**JOINT REGIONAL PLANNING PANEL
(Sydney East Region)**

JRPP No	2016SYE015
DA Number	DA487/2015
Local Government Area	North Sydney Council
Proposed Development	Demolition of existing residential flat building and construction of mixed use building consisting of 113 apartments, commercial space and 85 car-spaces (Amended proposal)
Street Address	229 & 231 Miller Street, North Sydney
Applicant	Yaver Pty Ltd
Owner	Yaver Pty Ltd
Number of Submissions	5 to original plans 1 to amended plans
Regional Development Criteria (Schedule 4A of the Act)	Capital Investment Value > \$20 m
List of All Relevant s79C(1)(a) Matters	North Sydney LEP 2013 - Zoning – B4 Mixed Use North Sydney DCP 2013 S94 Contributions SEPP No. 55 – Remediation of Land SEPP No.65 – Design Quality of Residential Flat Development – Apartment Design Guide SEPP (Building Sustainability Index: BASIX) 2004 SREP (2005) – Sydney Harbour Catchment
List all documents submitted with this report for the panel's consideration	Revision C Plans and Elevations - DA01 – DA46 prepared by PA Studio, , dated 26/04/16 Lodged 27/04/16 Stormwater Concept Plan, Floth Building Consultants, Revision P1, dated 18/12/15 Structural Design Statement,

Figure 9: Extract of Plan DA02(c) showing approved building outlines relative to subject site

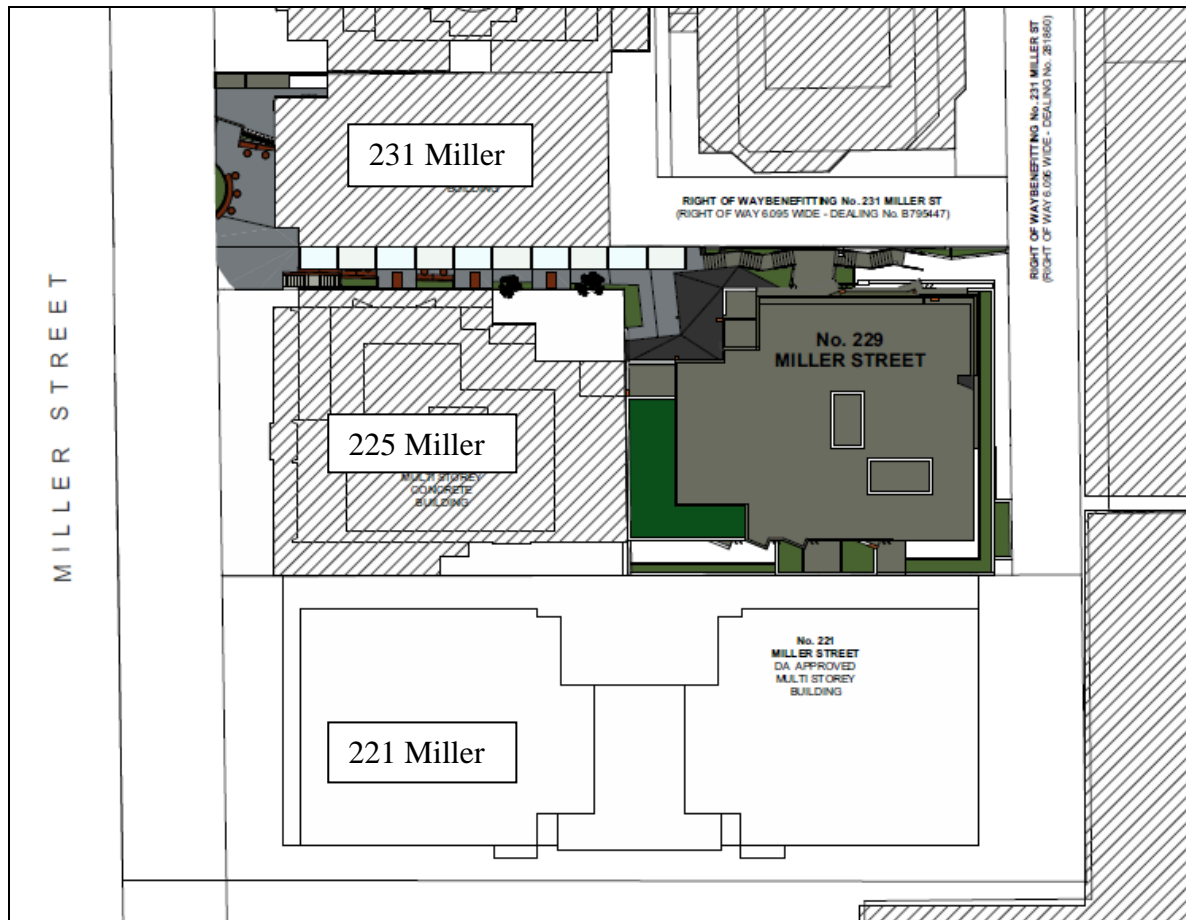
The proposed building is not fully compliant with setbacks and separation, and this in turn results in a substantial number of apartments having low amenity particularly at the lower levels of the building. The site constraints are such that a substantial reduction to the total number of apartments within the building is required to improve upon the overall residential amenity in particular the lower apartments.
